Title: **QUALITY AUDIT**

Road Safety Audit, Access Audit, Cycle Audit and Walking Audit.

**Carlisle Residential Development, Kimmage Road West,
Kimmage, Dublin 12.**

Report reference: **2614R01**

3.1 Problem

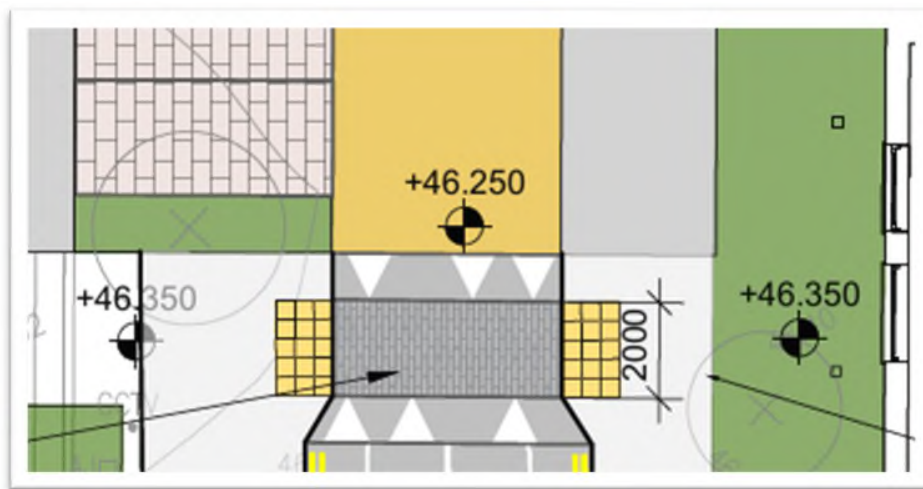
Drawing CST-BMD-00-ZZ-DR-C-1017 PL Rev 5, Main access road, Pedestrian desire line to Ben Dunne Gym.

It is propose to provide a raised uncontrolled pedestrian crossing to the Ben Dunne Gym. Tactile paving is only shown on one side of the crossing. Without adequate warning blind or partially sighted pedestrians may not know that they are entering a space shared with vehicular traffic. This would increase the risk of collisions.

It is recommended that tactile paving be provided at both sides of the crossing.

3.2 Problem

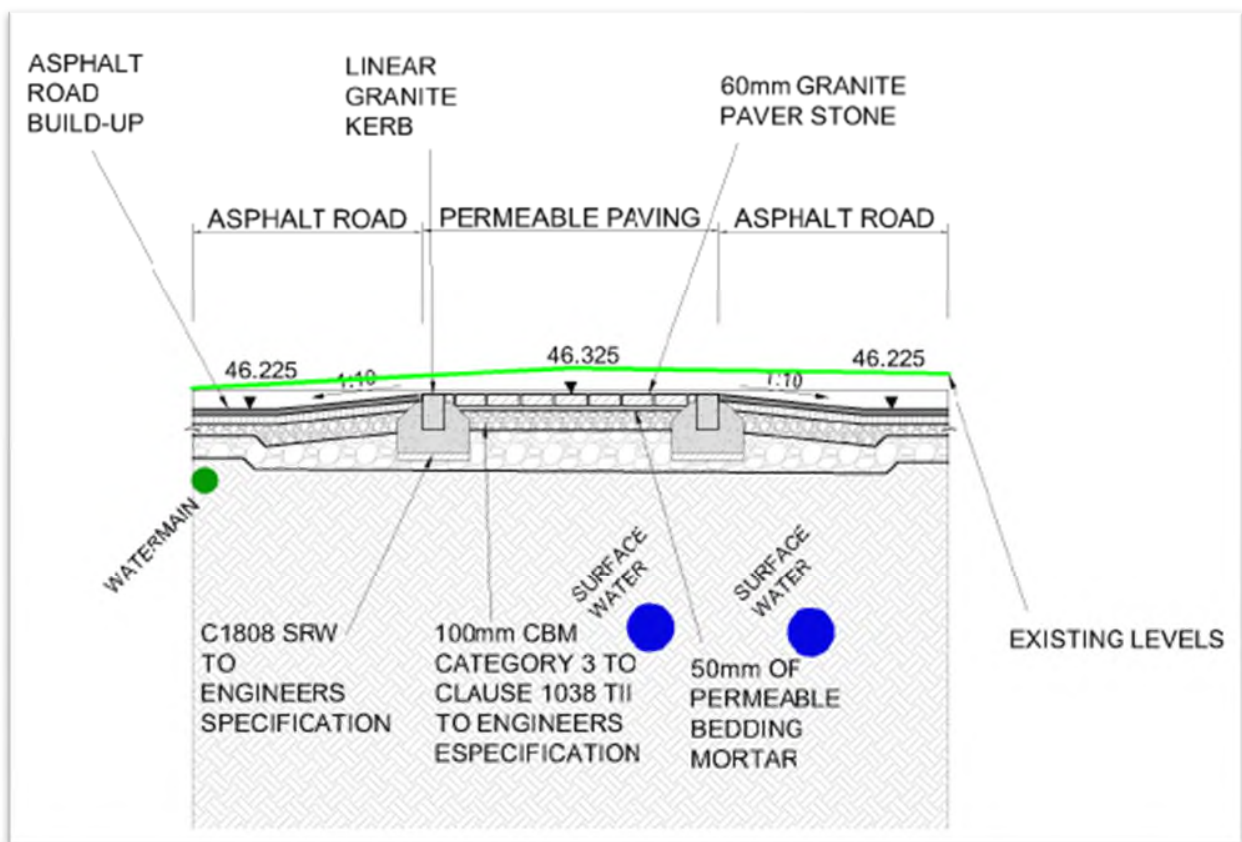
Drawing CST-BMD-00-ZZ-DR-C-1017 PL Rev 5, Entrance to Residential Area.

Drivers entering the residential area will be on a different surface type that will have pedestrians, cyclists and those getting into and out of their vehicles. Without adequate warning drivers may travel at excessive speed increasing the risk of collisions with those vulnerable road users.

It is recommended that a shared use type sign, similar to F404 of the Traffic Signs Manual be provided at the entry to this area.
